MMO Reference: DCO/2022/00007
Planning Inspectorate Reference: EN010125
Identification Number: 20050160

Planning Act 2008, RWE Renewables UK Dogger Bank South (West) Ltd and RWE Renewables UK Dogger Bank South (East) Ltd Proposed Dogger Bank South Offshore Wind Farms Order

Deadline 4

Figure 1 – Figure 2.7 taken from the Deadline 1 Heat Mapping Report

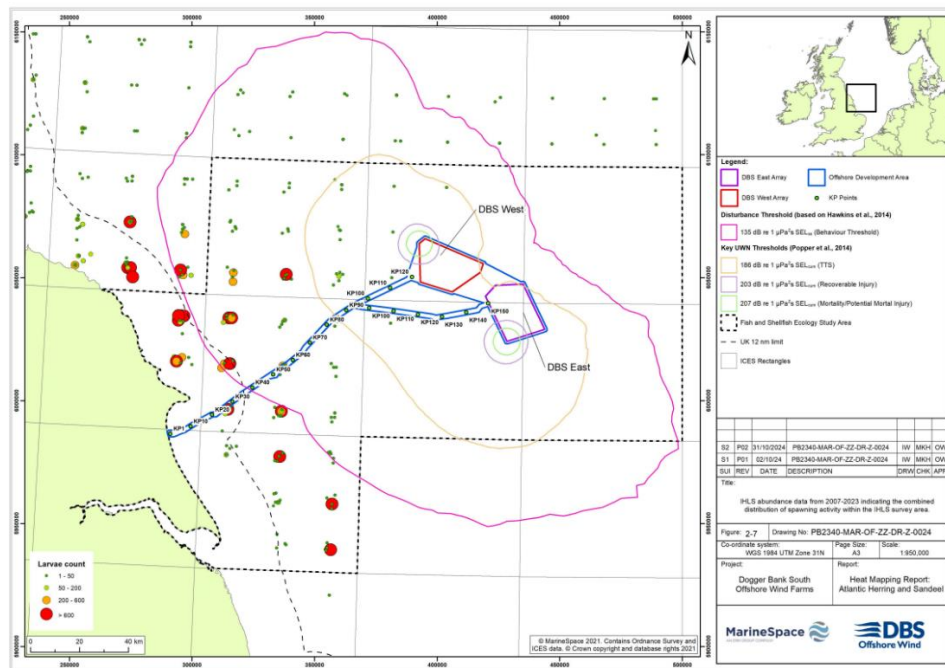
"The Applicant's would like the MMO to clarify whether the >600 larvae per metre squared (m²) category consists of anything other than high abundance that would warrant a change to the figure's legend, and if so, what the updated categories should be; bearing in mind the intention of the display of IHLS abundance data in this report as an indicator of spawning activity."

1.7.3 With regards to the Applicant's request for clarification on "whether the >600 larvae per m² category consists of anything other than high abundance", it is not entirely clear what they are asking. In brief, no, the MMO would not expect there to be a category higher than 'high abundance' (assuming the four categories in the Applicant's original plot represent very low, low, medium and high larval abundance, see Figure 1 below), however this is not what the MMO was asking for in previous advice. The MMO apologises if this was unclear. As outlined in the advice, a high abundance category of >600 larvae/m² is not appropriate when presenting larval data for a 15-year period, for the purpose the Applicant is using it for, as it is not uncommon for areas within the main spawning grounds to record thousands, or tens of thousands, of larvae per m² and so a point on the map indicating '>600 larvae/m²' could be representing a density of 601, or 6000 larvae/m², there's no way to differentiate between these values, or from which year of data these values come from. From example an area of spawning ground may have a larval abundance of 6000 larvae/m² at the beginning of the timeseries, but see larval abundances decrease overtime, however this is not reflected on the current presentation.

- 1.7.4 In order to fully examine and understand the spatial and temporal variation in herring spawning activity across the spawning ground, relative to the location of the export cable route, it is necessary to see each year of data presented individually with a consistent scale showing contours of larval abundance in m² with a figure legend representing the concentration of larvae within each band. The MMO has included an example of a similar map produced by the Applicant of the Rampion Extension (Rampion 2) OWF project as an example of what we are looking to see (Figure 2 (a-c)).

Figure 2a – Maps taken from Rampion 2 extension Offshore Wind Farm

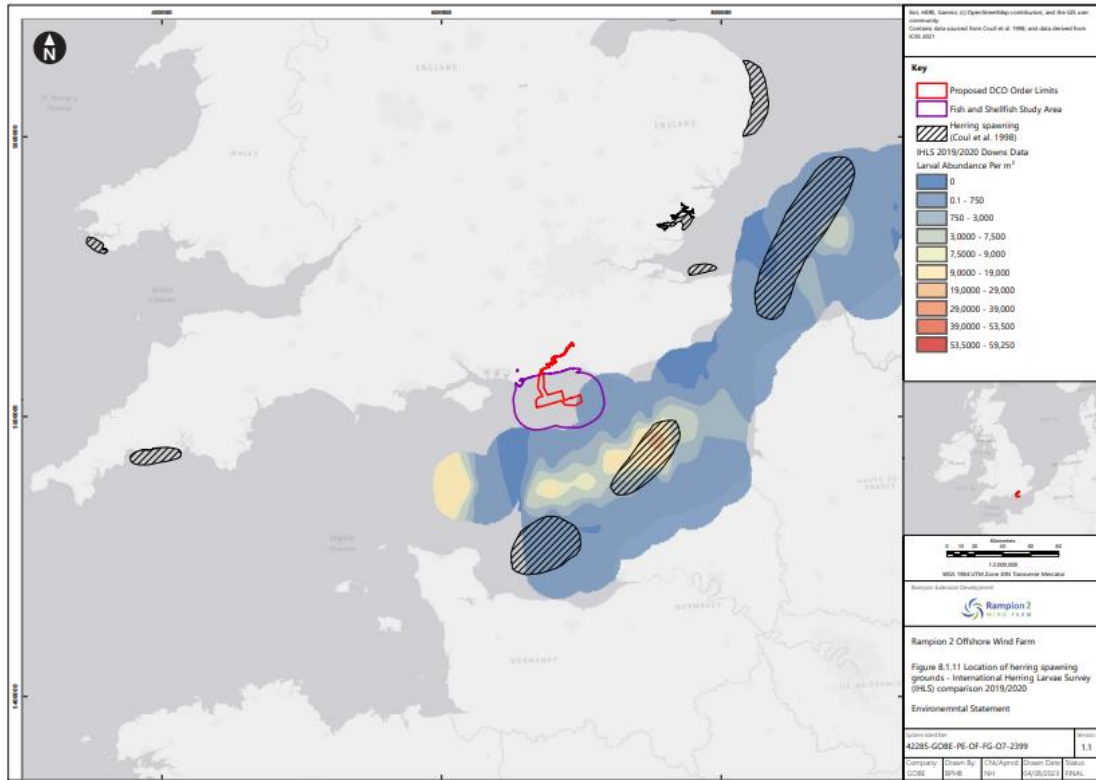
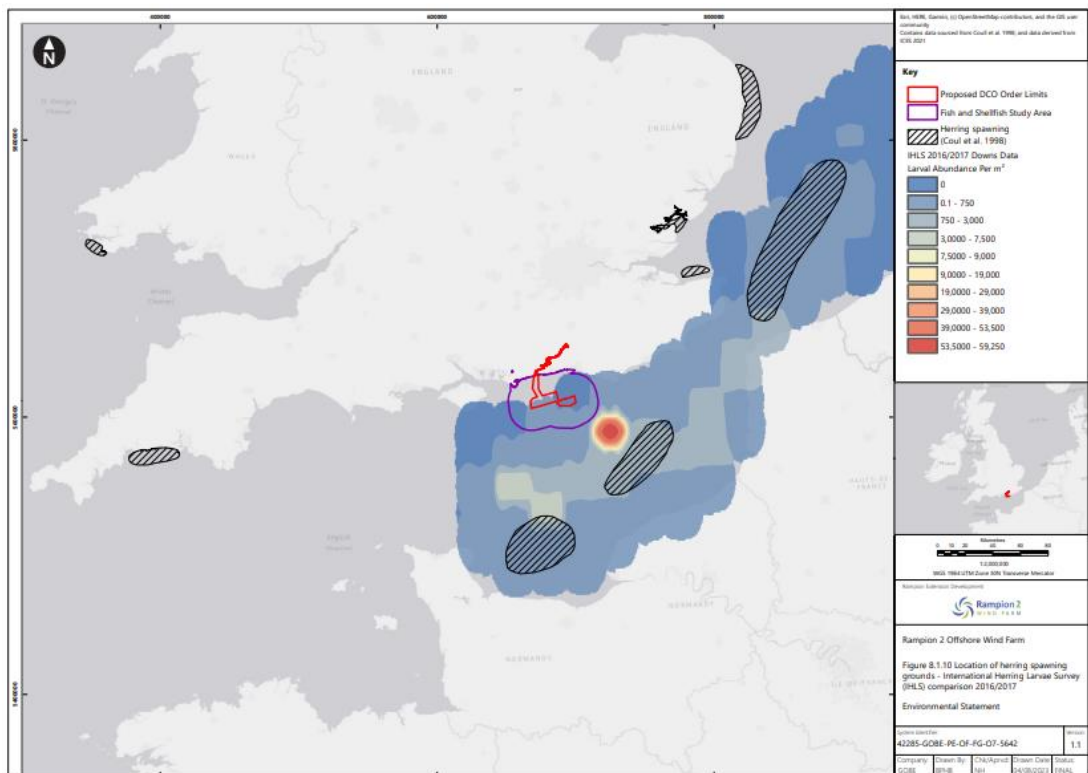
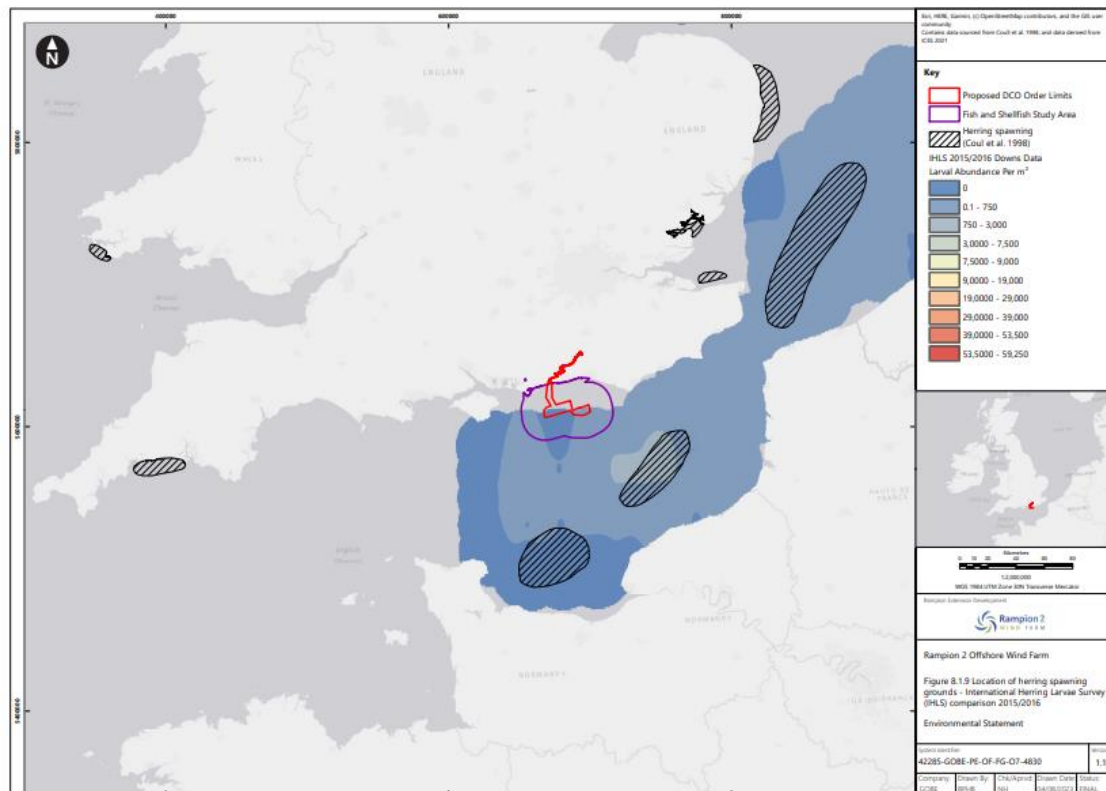
- 1.7.5 The Applicant should note that each year of data is presented as a separate plot, and that the figure legend corresponds to the varying bands of ‘heat’ with a range of larval abundances. The scale in these example figures from Rampion shows range bands of herring larval abundances which are consistent between figures. The Applicant is already in possession of 15 years of IHLB data as this has been used to provide Figure 2.7 in the original Deadline 1 heatmapping report. In providing each year of IHLB data as standalone annual ‘heat’ maps, the Applicant will demonstrate where there are areas of consistently high or low spawning activity relative to the location of the export cable route. This will support any possible refinement of the recommend restriction on cable works, alongside the other key missing evidence requested section 2.2.10
